**1.5 81-83 MADELEINE ROAD CLAYTON
USE AND DEVELOPMENT OF A THREE STOREY BUILDING FOR STUDENT
ACCOMMODATION
(TPA/51572)**

This application proposes the construction of a three storey purpose built student accommodation building above a basement car park.

The proposed development is considered appropriate having regard to the relevant provisions of the Monash Planning Scheme. It is recommended that Council resolve to issue a Notice of Decision to Grant a Planning Permit, subject to conditions.

Overshadowing

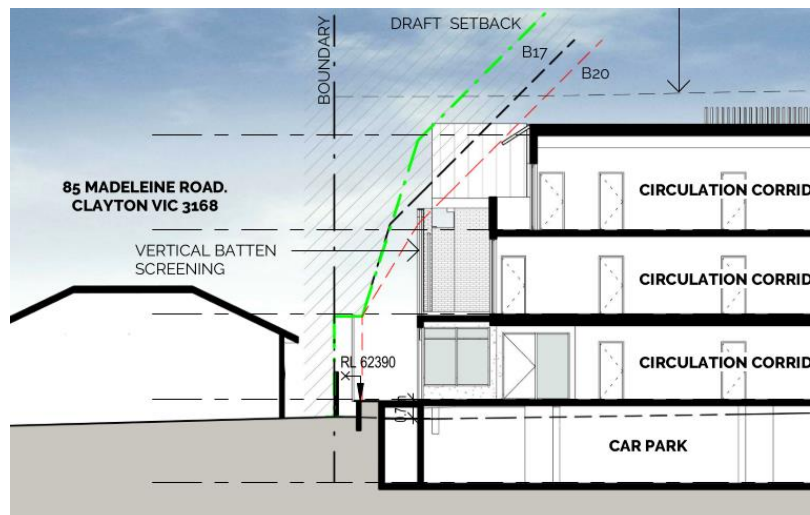
Shadowing diagrams prepared show that additional shadow will be cast into the property of 29 Lillian Street at 9am and 10am at the equinox. However, shadowing to this property is limited to accessways and roofed areas.

Additional overshadowing will occur to the open space of 85 Madeleine Road throughout the day on the equinox. Whilst the open space area of this dwelling is large, it is considered that the primary area of secluded private open space is located directly to the rear of the dwelling, on the northern side of the shed. This area makes up a total of approximately 130sqm.

The greatest amount of shadow to this area will occur at 2pm and 3pm, however even at this time the shadows are limited and more than 75% of this area will receive sunlight.

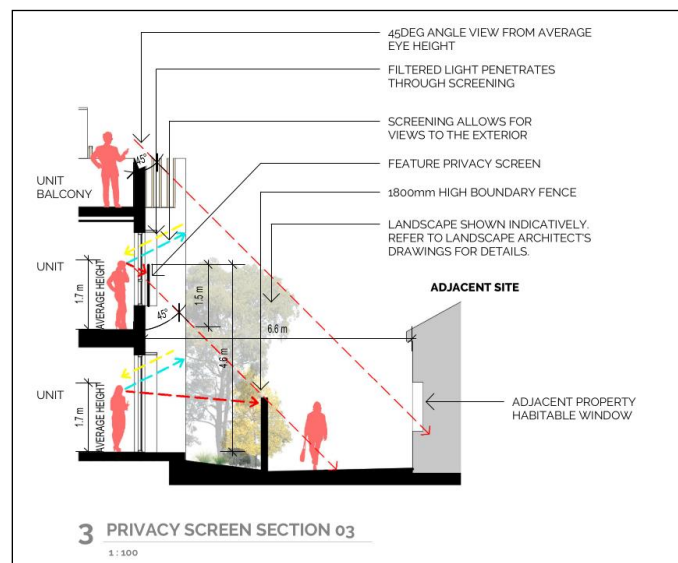
The pathway along the southern boundary is raised, and will result in overlooking whilst using this pathway given the pathway and courtyard area are raised a maximum of approximately 1 metres above natural ground level at the boundary, and a 1.8m high paling fence is proposed along the southern boundary of the site.

The applicant has advised that the pathway is required for fire access regulations, and is not clear if the pathway can be lowered in height. It is noted that the pathway is not located above the basement car park.

A proposed condition will require the level paved central courtyard area to be set back a minimum of 3 metres from the southern boundary (which would be in line with the basement car park), to allow for additional landscaping in this area and also provide for necessary screening by way of a freestanding screen. Steps and an access path may encroach into this area. A freestanding screen will be required to prevent overlooking, rather than additional height to the boundary fencing.

The access door on the southern side of Room 13 is also raised above natural ground level and the landing space will potentially result in unreasonable overlooking. It is understood that this door is required for fire access requirements. A proposed condition will require signage on this door to limit access for emergencies only, and will require the glazing adjacent to the door to be frosted.
